MIDLAND - SEISMIC INPUT

MEMORANDUM FOR: Robert E. Jackson, Chief
Geosciences Branch, DE

FROM: Jeff Kimball, Seismologist
Seismology Section
Geosciences Branch, DE

SUBJECT: SEISMOLOGICAL INPUT PARAMETERS IN RELATION
TO GEOSCIENCES AND GEOTECHNICAL REVIEW OF
MIDLAND 1 & 2

PERIOD-SEC.

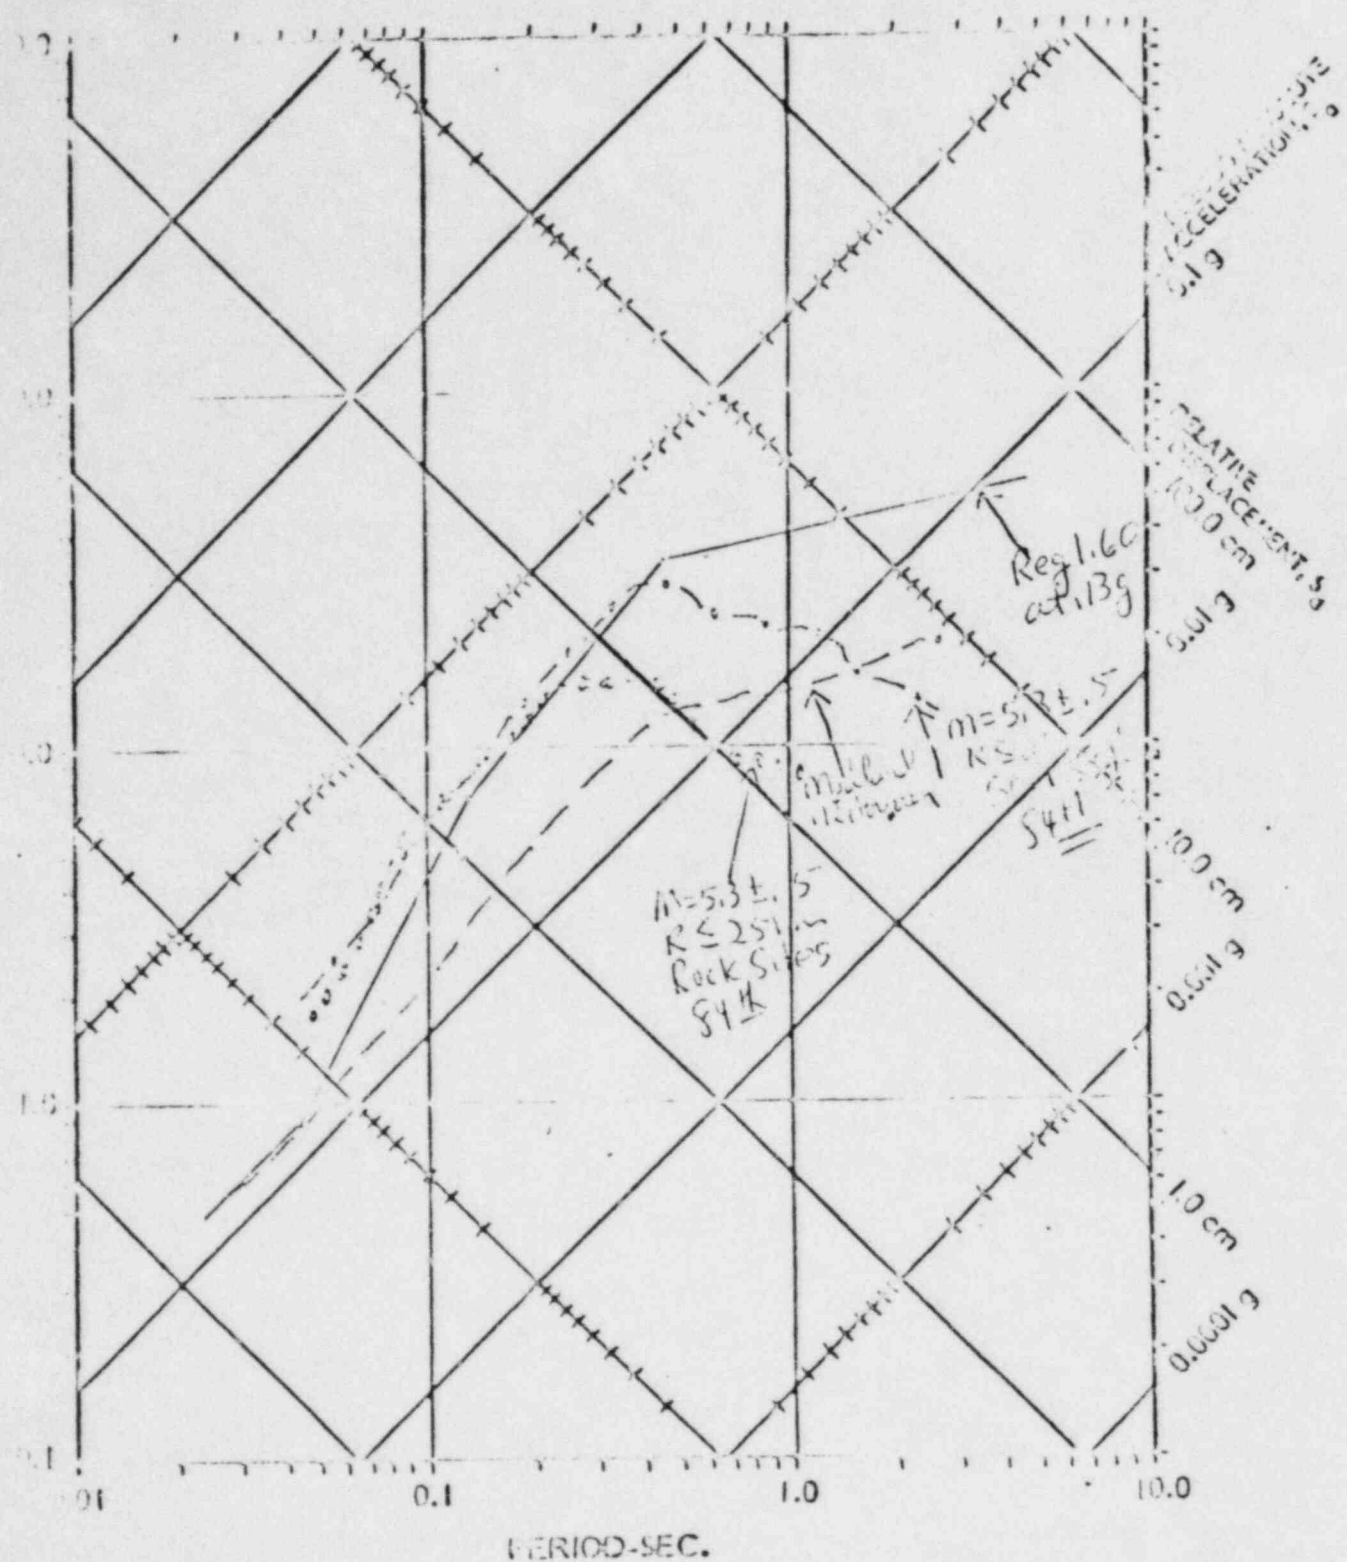
The Anna Ohio earthquake had an estimated body wave magnitude (mbLg) of about 5.3 and an intensity of about VII-VIII. Both magnitude and intensity were used to generate different response spectra. Results from the above methods indicate that the 84th percentile response spectrum calculated from real time histories (from SSSP M-5.3 ± .5 soil sites) is similar to Reg. Guide 1.60 anchored at .13g at frequencies of interest. When using the Standard Review Plan and the intensity of the controlling earthquake (VII-VIII), the response spectra (Reg. 1.60) is anchored at .19g using the trend of the means from Trifunac and Brady (1975). The applicant originally anchored the response spectra at .12g and used a Housner spectrum over the entire frequency range. With this in mind (characterizing the earthquake in terms of magnitude and (or) intensity), I suggested that Reg. Guide 1.60 anchored at .13g or appropriate real time histories could be used as response spectra for the site.

3. The 84th percentile (mean plus one standard deviation) response spectra should be used as input at the top of the uppermost cohesive till unit. Above the till is a thin but variable sand layer and plant fill. The applicant could then calculate the motion that would occur at the various structural foundations as a part of the soil-structure interaction analysis which should adequately address soil amplification.
